CUT PATTERN	
BACK FRAME NO.	
BASE FRAME NO.	
WOOD PATTERN

*ARM FRAME DETAIL (SIDE VIEW)

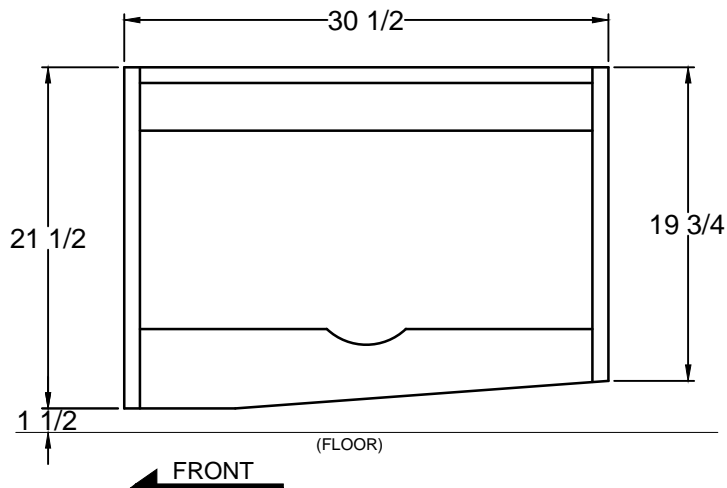
JA	D	PRODUCTION UPDATE: [1] ADD ARM FRAME DETAIL. [2] CHANGE ARM FRAME WIDTH TO 2-1/4"; WAS 2".	01.29.19
FP	C	PER RL: [1] ADJUSTED ARM HEIGHT TO 24 1/2" WAS 21"; [2] ADDED DIMENSION OF 20"; [3] ADJUSTED WIDTH TO 28 1/2" WAS 29"; [4] ADJUSTED G.A. HEIGHT TO 37 1/2" WAS 40 1/2"; [5] ADJUSTED FRAME HEIGHT TO 36" WAS 38"; [6] ADJUSTED DEPTH TO 34 1/2" WAS 36 1/2"	01.02.19
AC	B	PRODUCTION UPDATE: ADDED FOAM INFORMATION.	03.27.18
JA	A	PER RL, CHROME STRIP ADJUSTMENTS.	03.21.18
